Access Compliance Report Public Rights-of-Way (Pedestrian Signals)

Main Street: **ORANGE_AVE** Cross Street: **S_BROOKHURST_ST** Location: **SE**

ADA ID: **SGRK220218200031** Signal Type: **One Push Button-Non APS** Overall Compliance: **No** Severity Scores: **BTN 1: 10** **BTN 2: N/A** **No BTN: N/A**

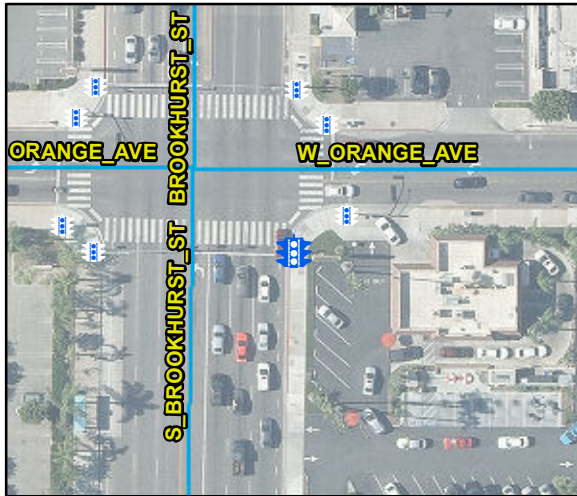
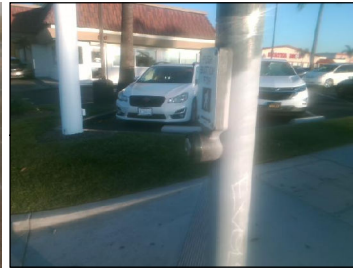
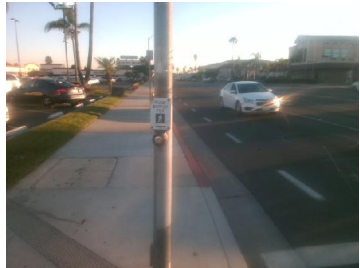
OC Std/PROW: **MUTCD 4e.08**

Possible Solutions: Replace Signal Push Button With APS Button.
